STAFF RECOMMENDATION
1426 Roberts Avenue
August 16, 2017

Application: New construction – outbuilding; Setback determination
District: Eastwood Neighborhood Conservation Zoning Overlay
Council District: 06
Map and Parcel Number: 083 02 0 101.00
Applicant: Merrilyn Gatlin
Project Lead: Paul Hoffman, paul.hoffman@nashville.gov

Description of Project: The applicant is proposing to construct a new outbuilding at the rear of the lot, requesting a setback determination for the rear setback, from ten feet (10') to eight feet (8').

SHARPE AVENUE
PLOT PLAN 1" = 20'-0"

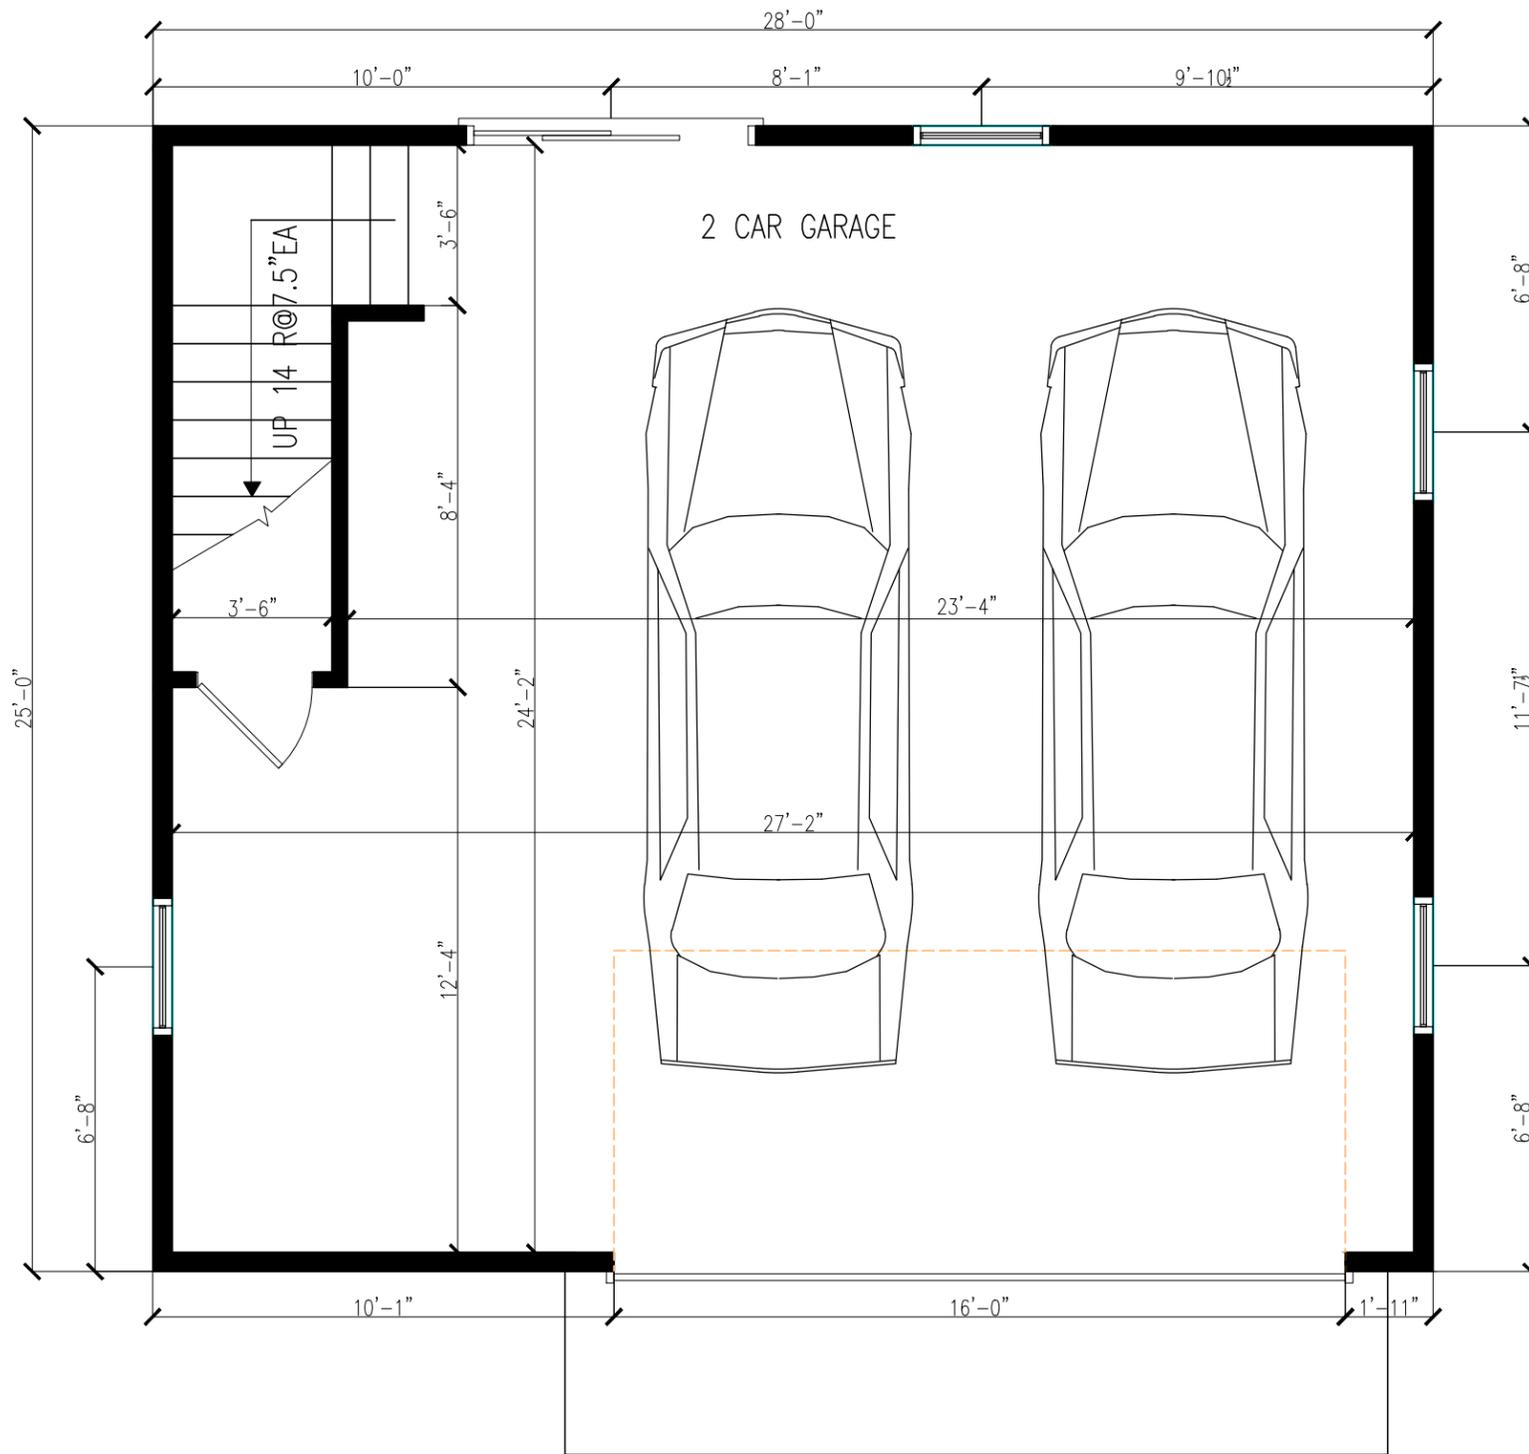
Site Planning & Setbacks: The outbuilding will be at the rear of the lot, with a rear setback of eight feet (8') and side setbacks of three feet (3') and nineteen feet (19') from the left and right sides, respectively. It will be separated from the house by approximately fifty-four feet (54'). The outbuilding will have a footprint of seven hundred square feet (700 sq. ft.), therefore Code requires a rear setback of ten feet (10').

Historically, outbuildings have been located close to the rear property line. Additionally there are existing outbuildings near the rear property line of this block. Staff recommends approval of the reduced rear setback, finding that the proposed location meets Section II.B.h.2.

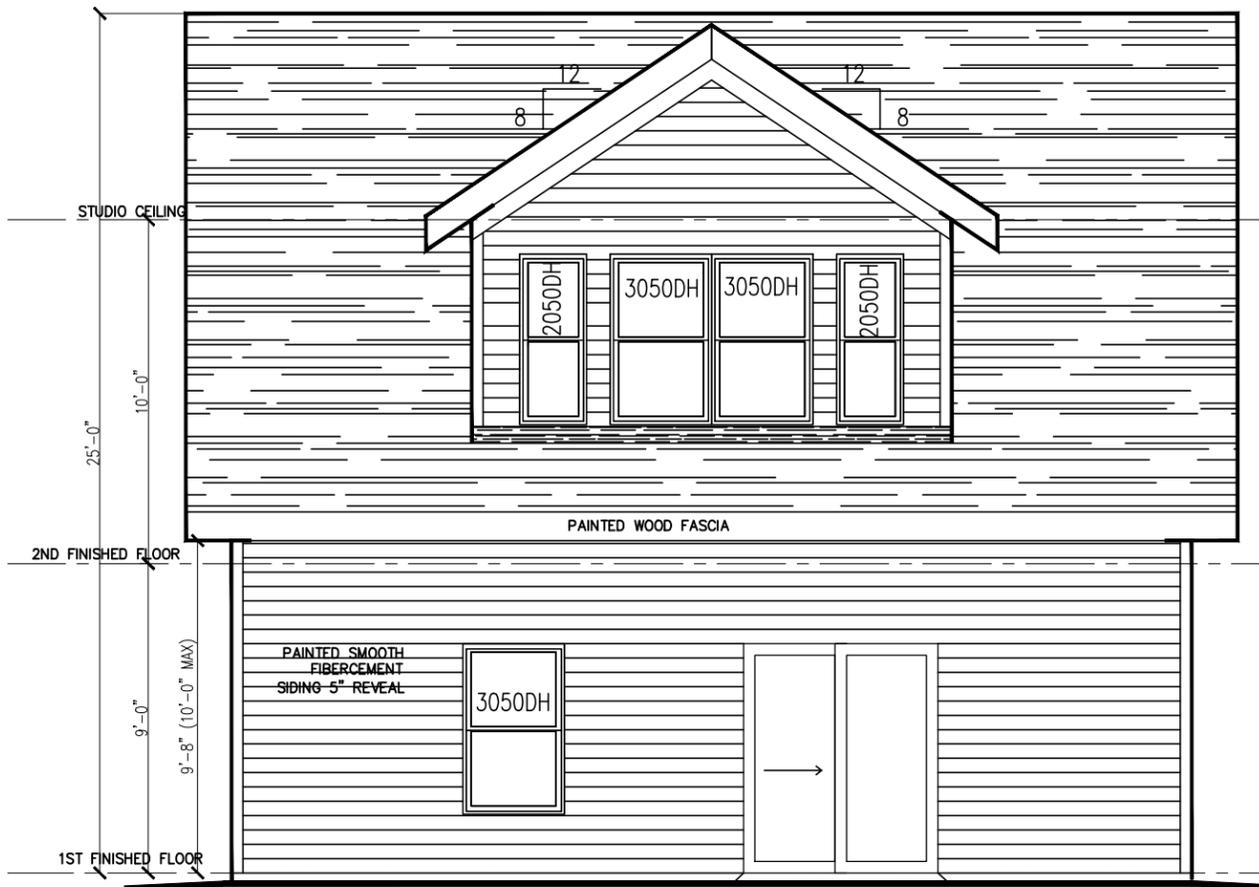
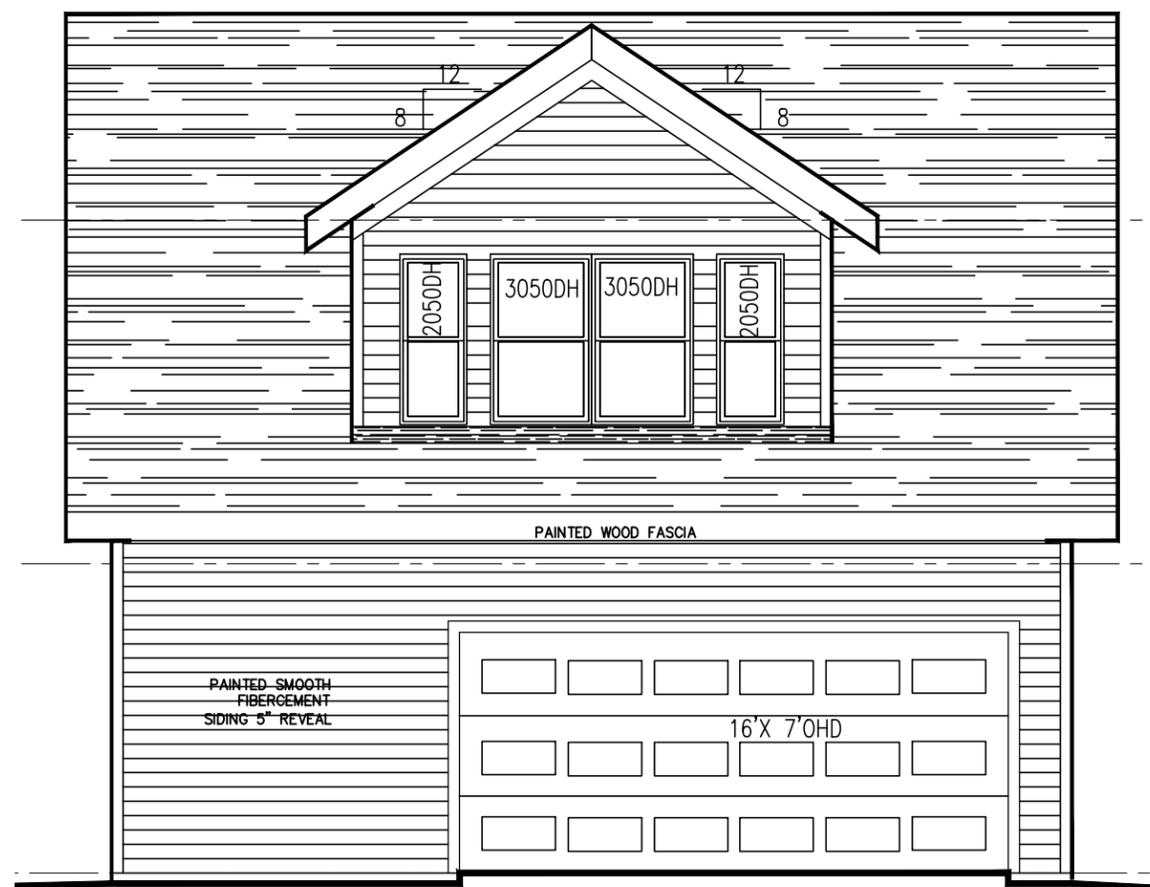
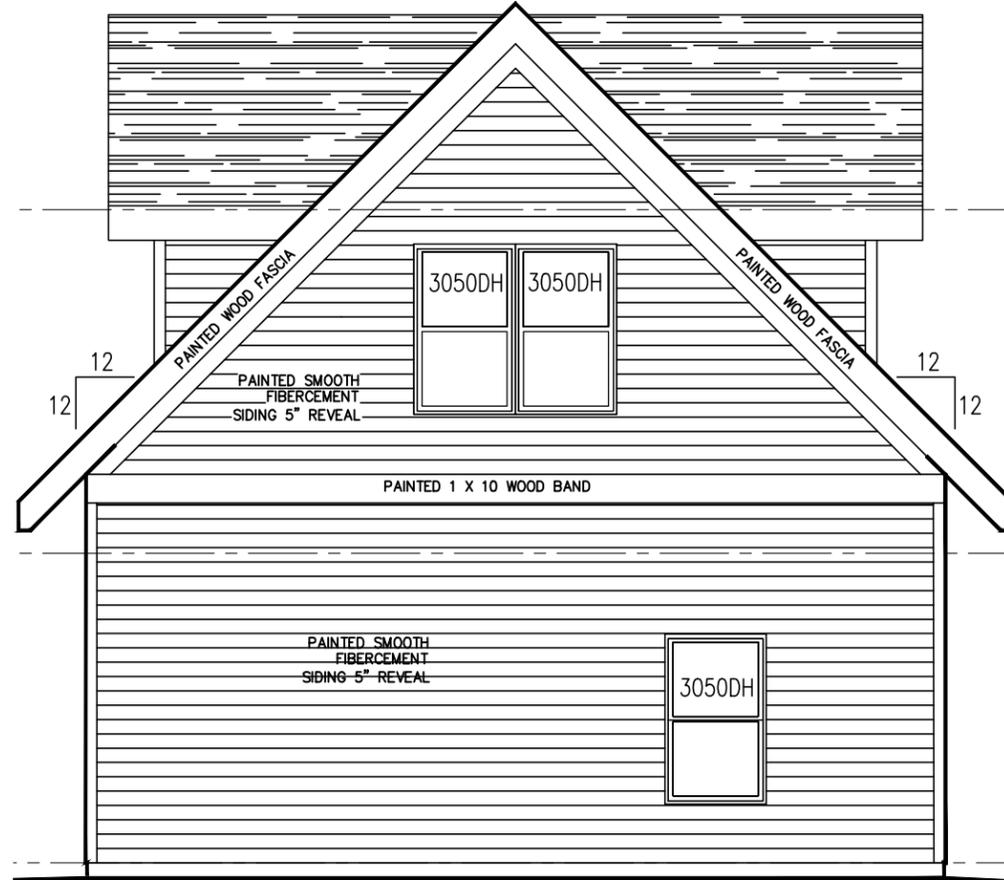
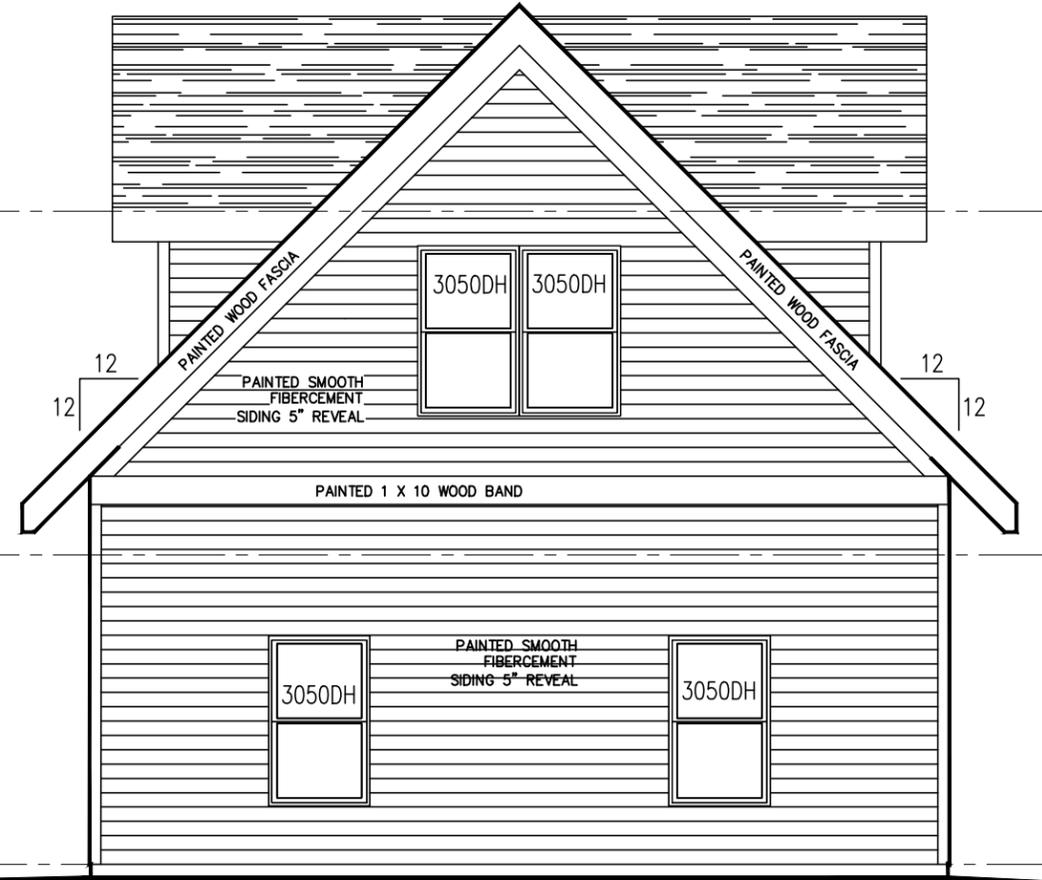
Scale: The proposed outbuilding will be one and a half stories and have a footprint of seven hundred square feet (700 sq. ft.), which is subordinate to the historic structure. The ridge height is drawn at greater than twenty-five feet (25') from grade, which is taller than permitted. Staff therefore recommends that the ridge height be reduced to remain no taller than twenty-five feet (25') above grade.

The outbuilding has a dormer on each roof plane. The dormers are approximately half the width of the roof surface, and they are set back two feet (2') from the wall below them. Staff finds that the proposed outbuilding meets Section II.b.h.1 for the roof shape and elements.

Materials: The materials have all been approved by the Commission in the past, and include fiber-cement panel siding with a five-inch (5") reveal. It will be built on a concrete slab. The roof will be asphalt shingles. Windows and doors were not specified, and Staff recommends having approval of those materials. The garage door is one large door. As this is on a façade facing the rear street, Staff finds that it would be more compatible with the design guidelines for the building to have two smaller garage doors instead. The windows are drawn with brick mold instead of traditional casings; as this is not appropriate on a lap-sided structure, Staff recommends that the windows be installed with a nominal four inch (4") trim instead of brick mold. Additionally, the window sets are drawn with siding or butt-joined; therefore Staff recommends that the windows have a four-to-six inch (4"-6") mullion between them.

With the conditions that the windows are revised with four inch (4") casings, that the window sets have a four to six inch (4"-6") mullion between them, that the garage door is

revised to be two separate doors, and that Staff have approval of windows, doors and garage doors, Staff finds that the materials will meet Section II.B.h.1.
